WF087-03- Crown Trading Estate, Hayes, London

**RE: Crown Trading Estate, Hayes, London – Wind Microclimate Technical Addendum**

Figure A1. Comparative Drawings: Ground Floor Plan (previous design on the left, updated design on the right)

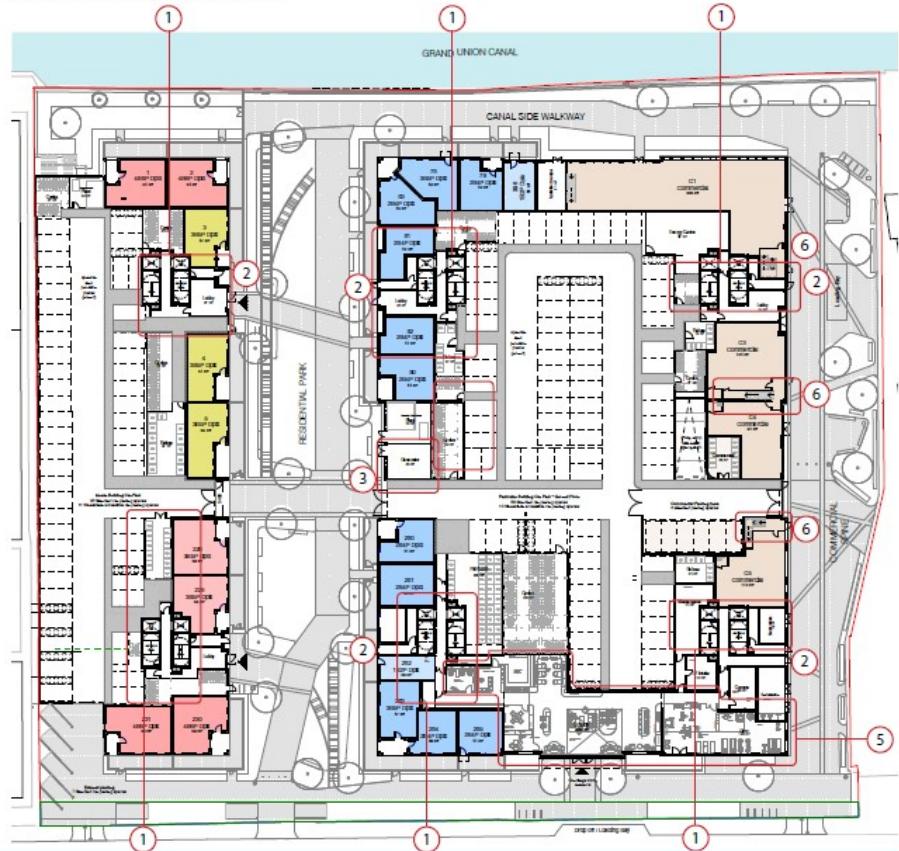
1. Second stair added with associated changes to adjacent cycle stores, car parking and plant rooms etc as required to allow inclusion of additional stair.
2. Direct escape to outside is maintained from one stair, while other stair provides day-to-day access to and from the car park to the homes.
3. Generator room relocated to comply with fire regulations.
4. Car park ramp removed to allow for readjustment & prevent
5. Interior design layouts for lobbies, staff room, office, mail rooms and the gym incorporated.
6. Enclosed escape stairs from Mezz floors of commercial units included to ensure compliance with future regulations.

Figure A2. Comparative Drawings: Mezzanine Plan (previous design on the left, updated design on the right)

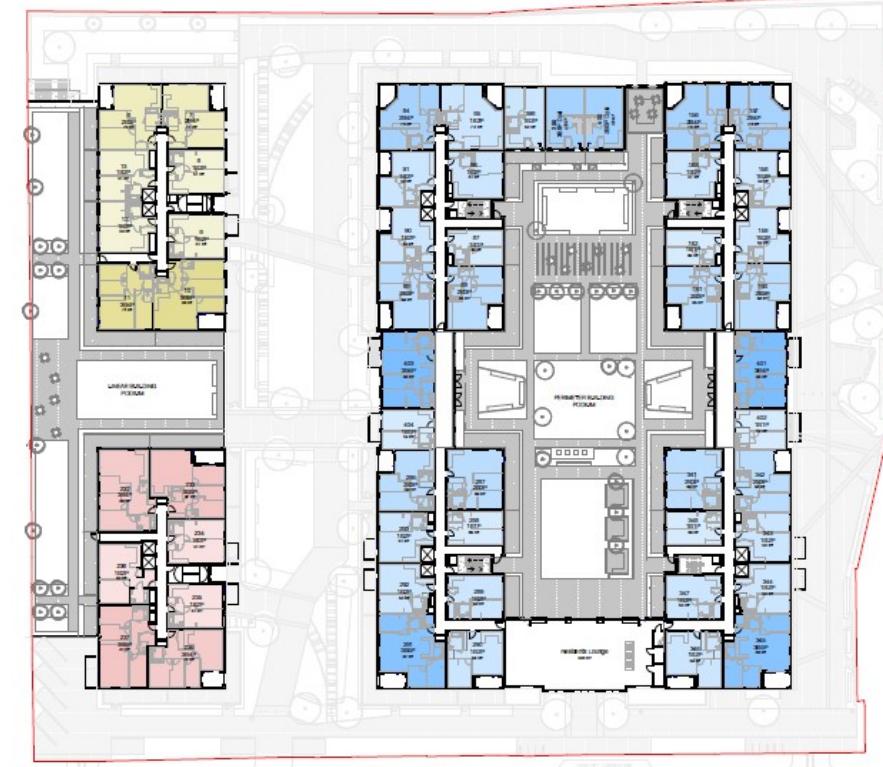
1. Second escape stair added to all cores to ensure compliance with future fire regulations. Adjacent homes, risers etc all adjusted to suit.
2. Commercial unit stair to comply with fire regulations and to provide protected escape routes on mezzanine floors.
3. Interior layouts for resident lounge and yoga room incorporated.
4. Ramp removed and car parking reduced to ensure no net increase in GIA from the approved scheme.

Figure A3. Comparative Drawings: First Floor Plan (previous design on the left, updated design on the right)

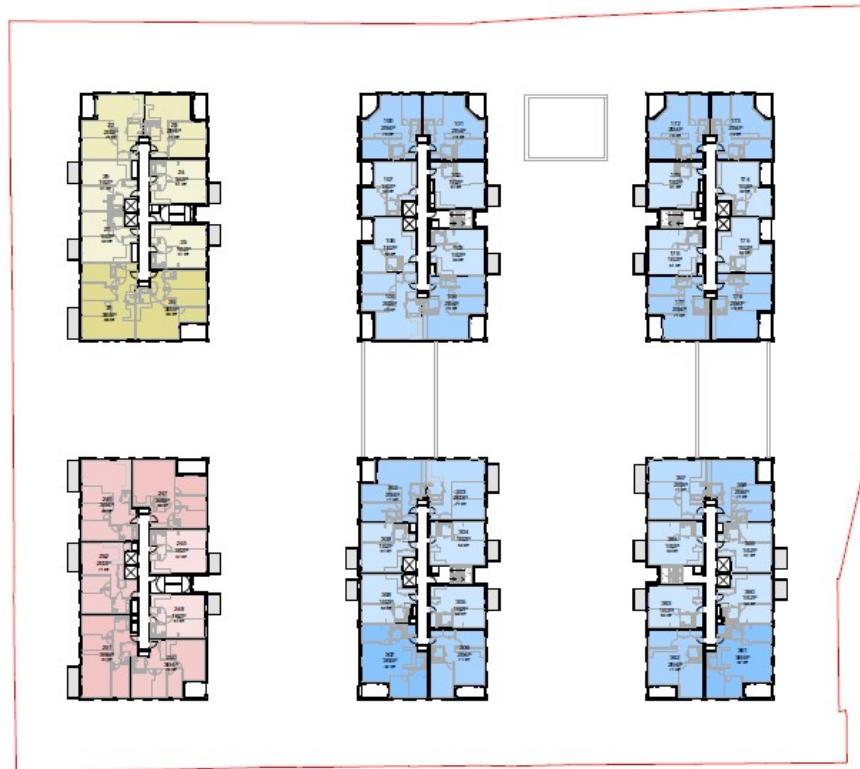
1. Second escape stair added to all cores to ensure compliance with future fire regulations. Adjacent homes, risers etc all adjusted to suit.
2. Nominal changes to balconies and facade to ensure that internal flat layouts retain compliance with future fire regulations and ensure escape past hob distances are reduced where possible as advised by JGA Fire.
  - Note - overall change in occupancy is required to allow for the additional stairs to be added. Generally this is done by a reduction of 1B2P homes to 1B1P homes. There is no proposed change to the number of family sized dwellings.

Figure A4. Comparative Drawings: Second Floor Plan (previous design on the left, updated design on the right)

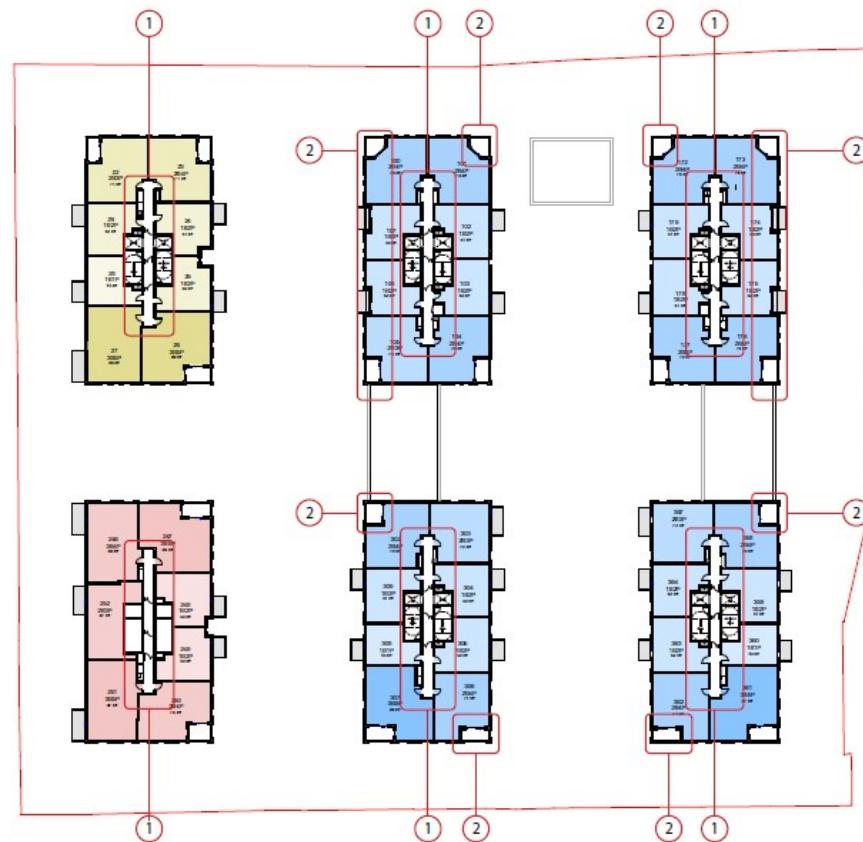
1. Second escape stair added to all cores to ensure compliance with future fire regulations. Adjacent homes, risers etc all adjusted to suit.
2. Nominal changes to balconies and facade to ensure that internal flat layouts retain compliance with future fire regulations and ensure escape past hob distances are reduced where possible as advised by JGA Fire.

- Note - overall change in occupancy is required to allow for the additional stairs to be added. Generally this is done by a reduction of 1B2P homes to 1B1P homes. There is no proposed change to the number of family sized dwellings.

Figure A5. Comparative Drawings: Third Floor Plan (previous design on the left, updated design on the right)

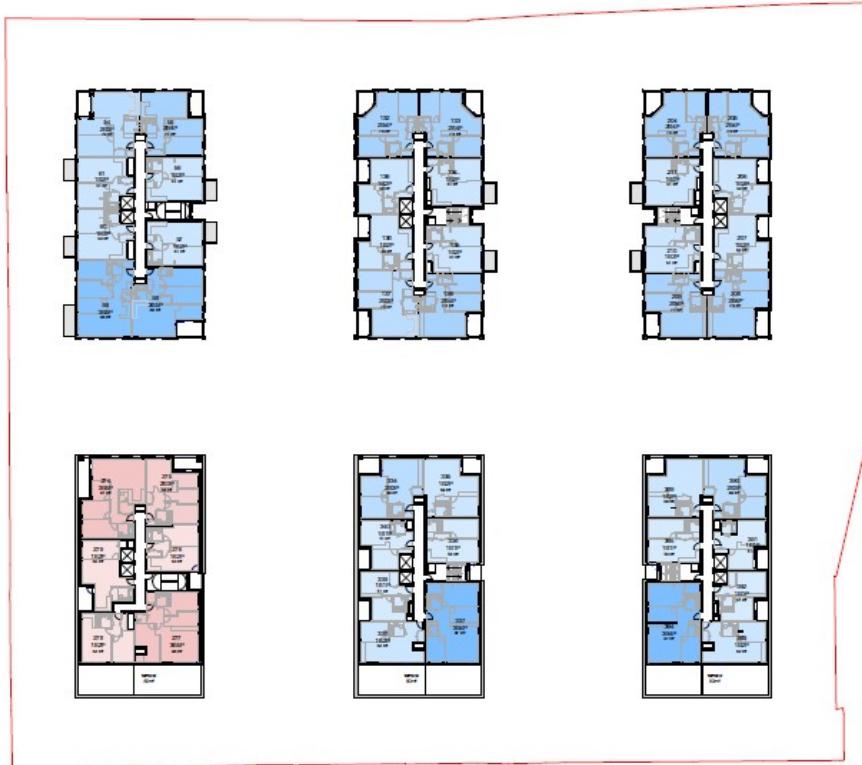
1. Second escape stair added to all cores to ensure compliance with future fire regulations. Adjacent homes, risers etc all adjusted to suit.
2. Nominal changes to balconies and facade to ensure that internal flat layouts retain compliance with future fire regulations and ensure escape past hob distances are reduced where possible as advised by JGA Fire.
  - Note - overall change in occupancy is required to allow for the additional stairs to be added. Generally this is done by a reduction of 1B2P homes to 1B1P homes. There is no proposed change to the number of family sized dwellings.

Figure A6. Comparative Drawings: Seventh Floor Plan (previous design on the left, updated design on the right)

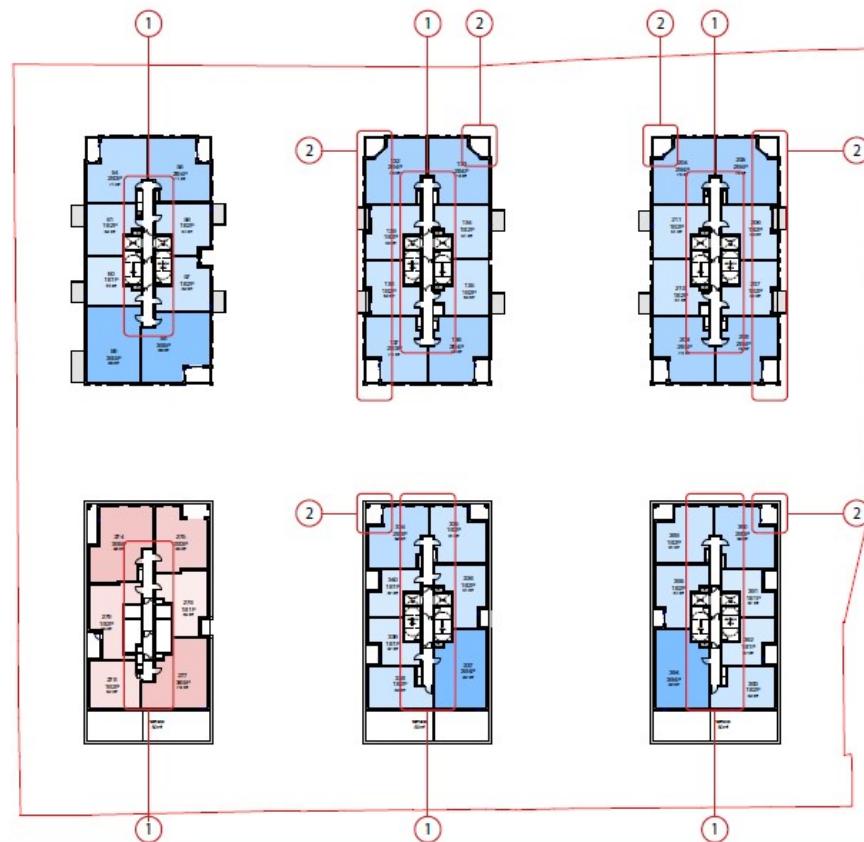
1. Second escape stair added to all cores to ensure compliance with future fire regulations. Adjacent homes, risers etc all adjusted to suit.
2. Nominal changes to balconies and facade to ensure that internal flat layouts retain compliance with future fire regulations and ensure escape past hob distances are reduced where possible as advised by JGA Fire.
  - Note - overall change in occupancy is required to allow for the additional stairs to be added. Generally this is done by a reduction of 1B2P homes to 1B1P homes. There is no proposed change to the number of family sized dwellings.

Figure A7. Comparative Drawings: Eighth Floor Plan (previous design on the left, updated design on the right)

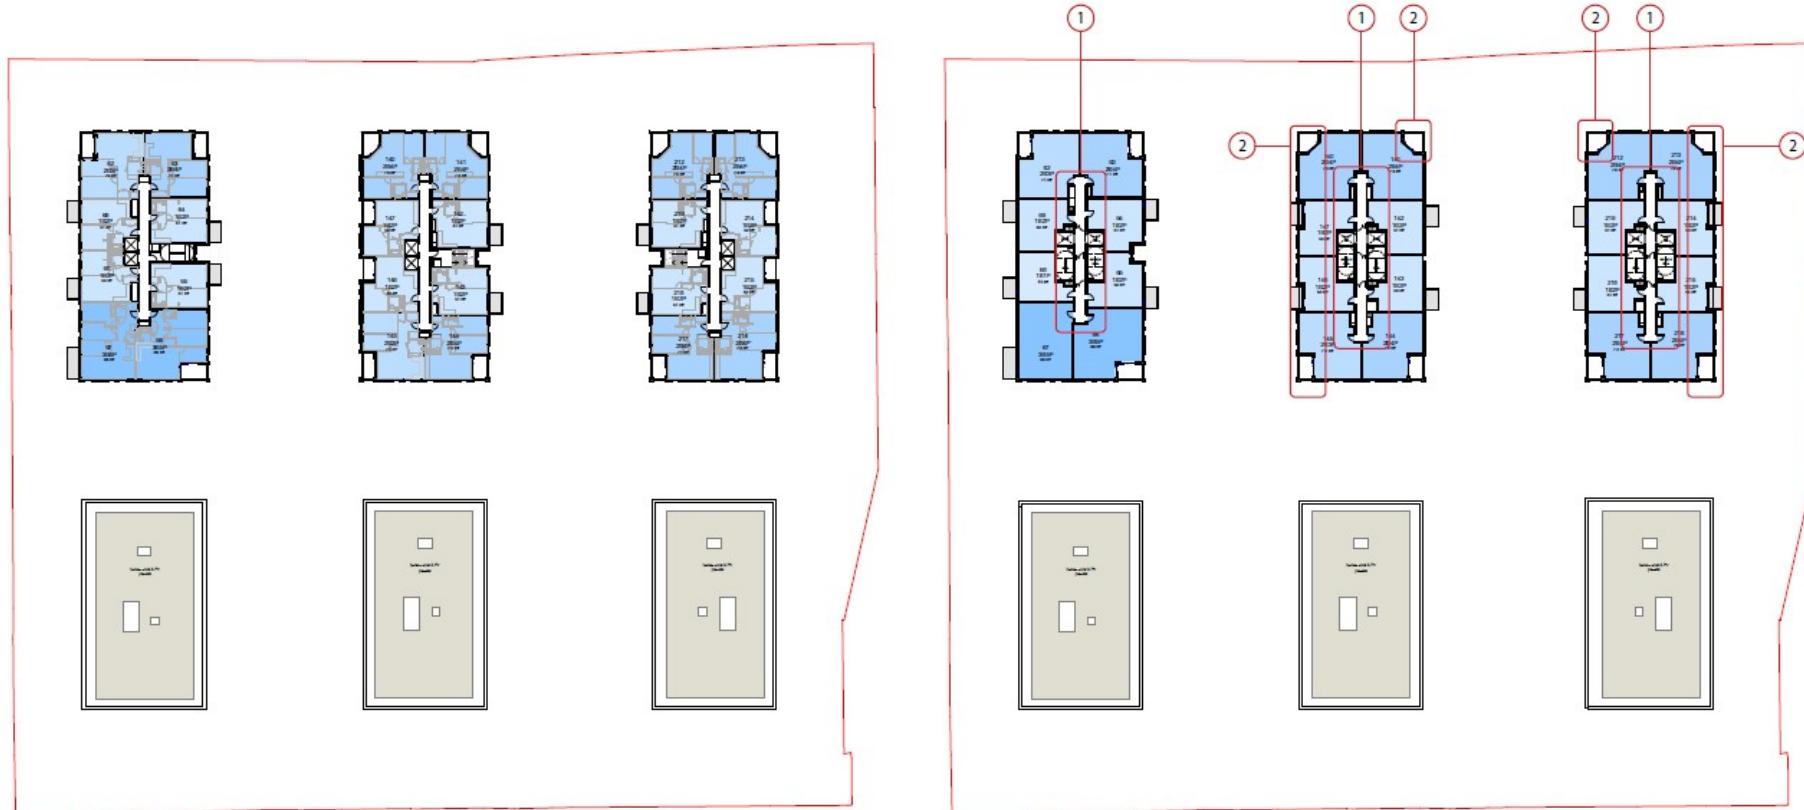
1. Second escape stair added to all cores to ensure compliance with future fire regulations. Adjacent homes, risers etc all adjusted to suit.
2. Nominal changes to balconies and facade to ensure that internal flat layouts retain compliance with future fire regulations and ensure escape past hob distances are reduced where possible as advised by JGA Fire.

- Note - overall change in occupancy is required to allow for the additional stairs to be added. Generally this is done by a reduction of 1B2P homes to 1B1P homes. There is no proposed change to the number of family sized dwellings.
